MODERNIZATION
FOR
COLONEL HOWARD NICHOLS
SCHOOL
3401 RENEGADE AVE.
BAKERSFIELD, CA 93306
BAKERSFIELD CITY
SCHOOL DISTRICT

BUILDING 1000
LIGHTING AND
POWER/SIGNAL
FLOOR PLANS

LIGHTING FLOOR PLAN BLDG. 1000

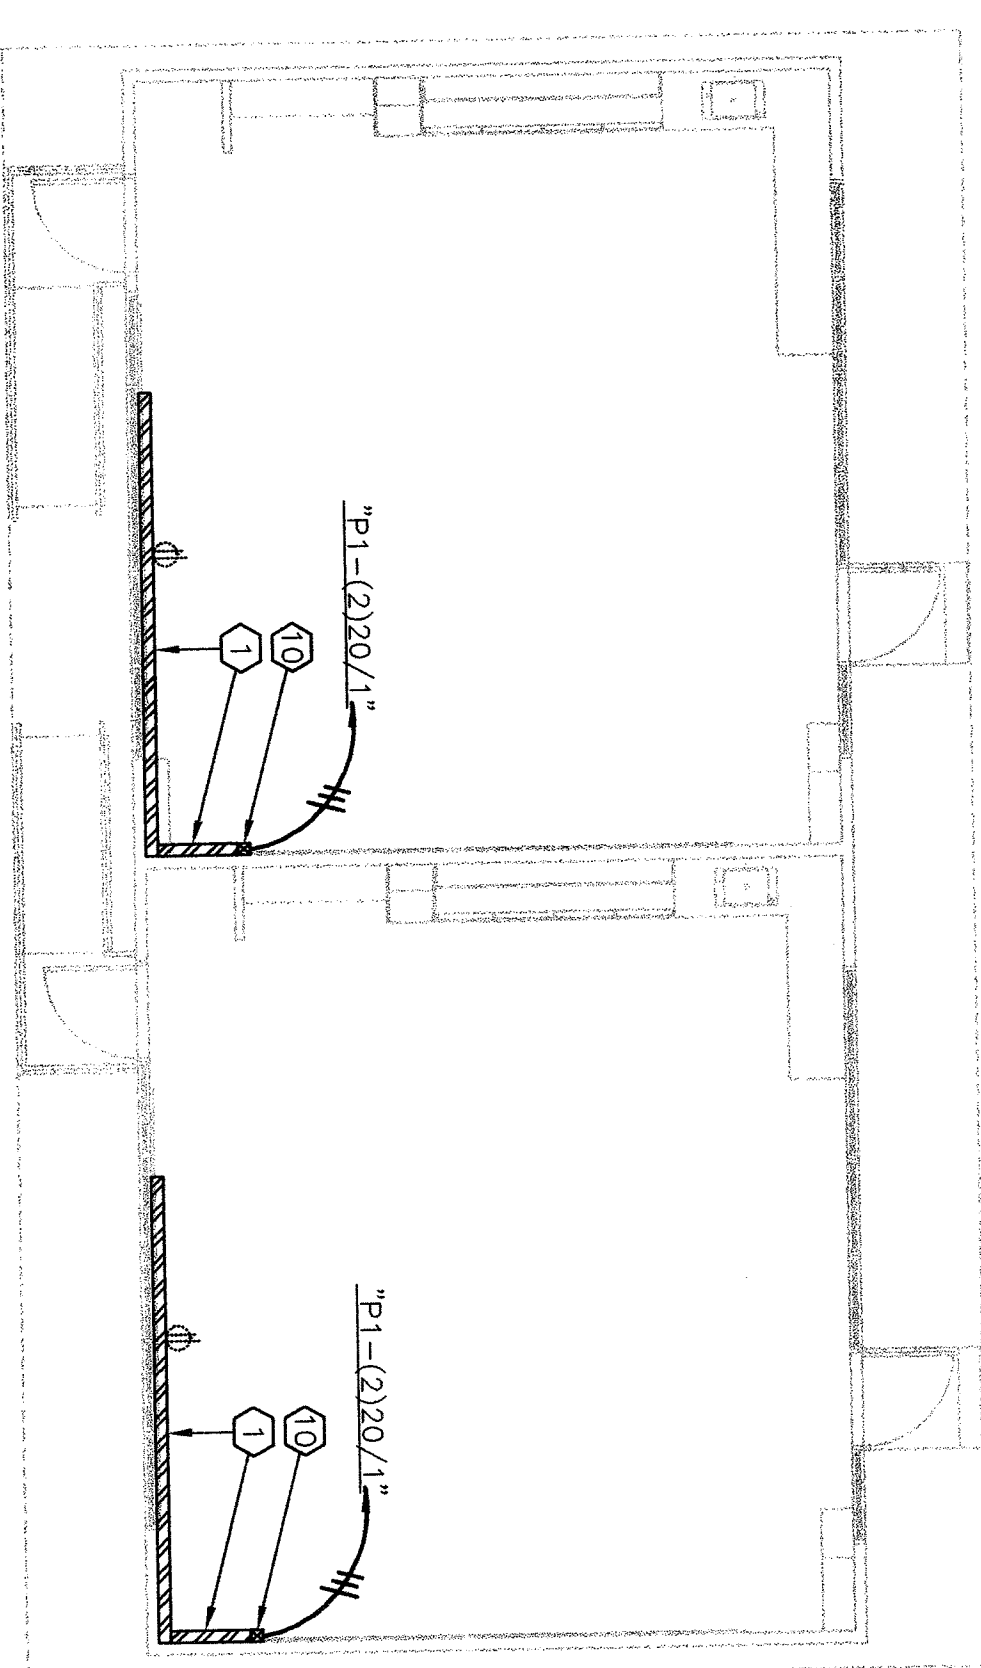
Item (9)
#12
Refer to Electrical Drawings, Sheet E2.71, "Building 1000 - Lighting Floor Plan."
CLARIFY contractor shall replace existing light fixture as indicated.
